Re: Former Star Facility
Mountainville, New York

The purpose of this letter is to present the results of the sub-slab vapor and indoor air sampling performed at the above-referenced site in accordance with the approved Site Investigation Work Plan. Additionally, as described below, a conceptual approach to mitigation of the sub-slab vapor detected is presented for your approval.

**SUB-SLAB DEPRESSURIZATION SYSTEM
PHASE I PLAN**

FIGURE 1

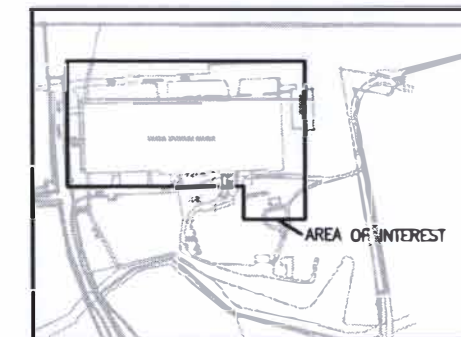
Handwritten notes:
 ?
 cis 12 and PCE
 only detected
 at IA-1
 where SS here much
 lower than @ SS-2

FIGURE NO. 2

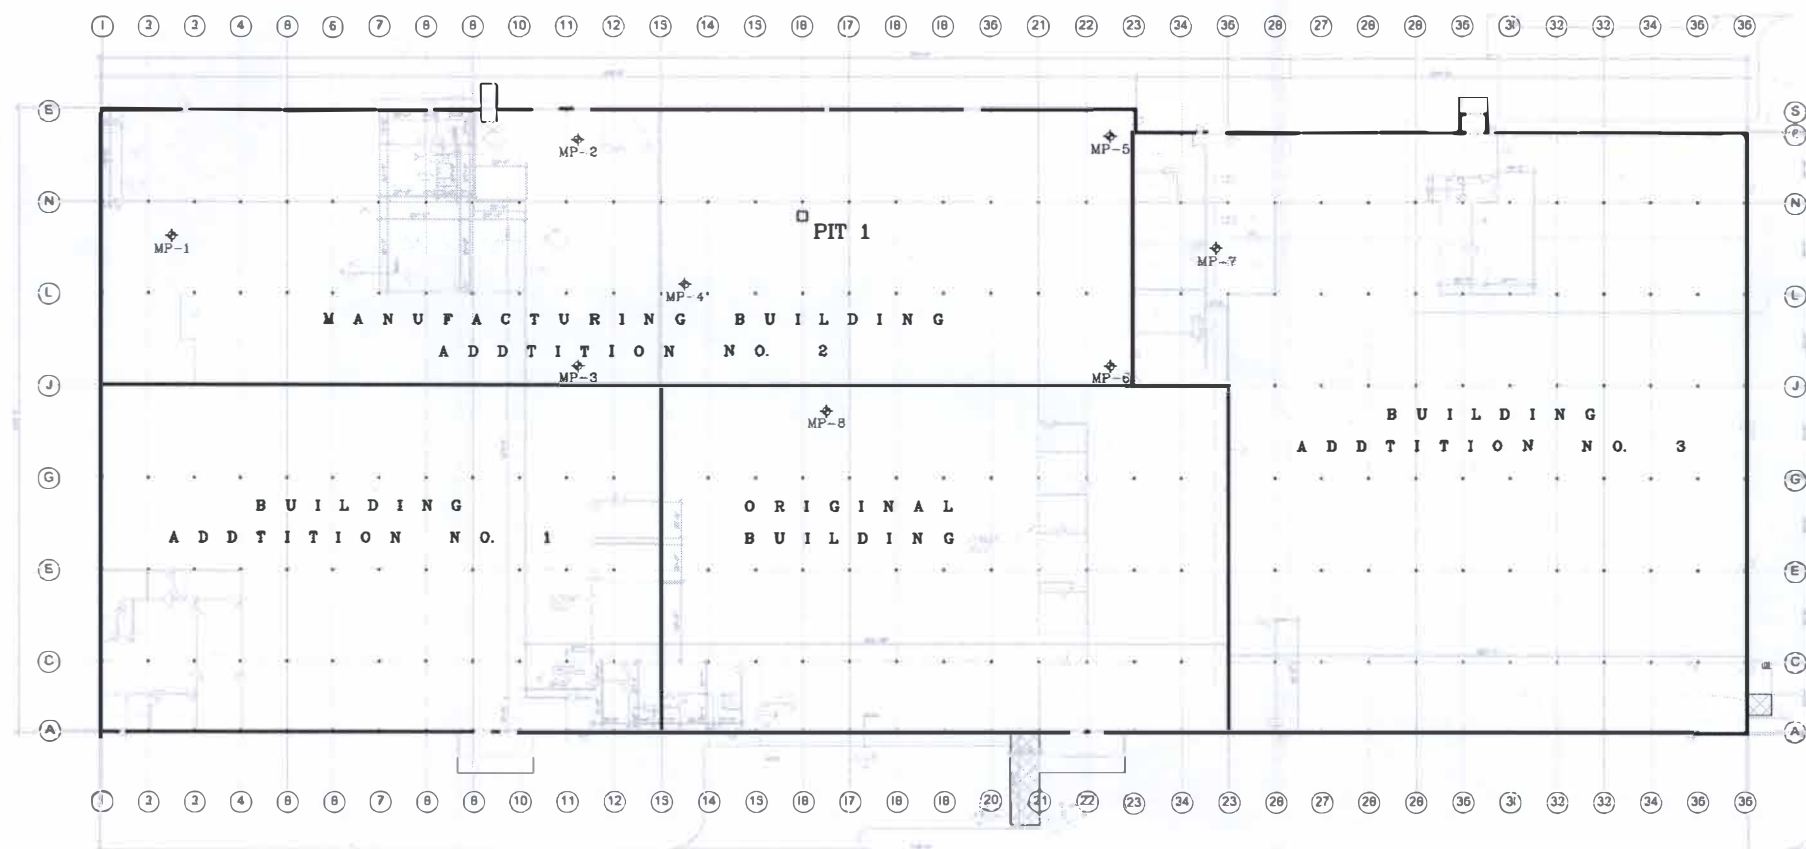
only mp 3 and mp 4 are
"radially outward" pair
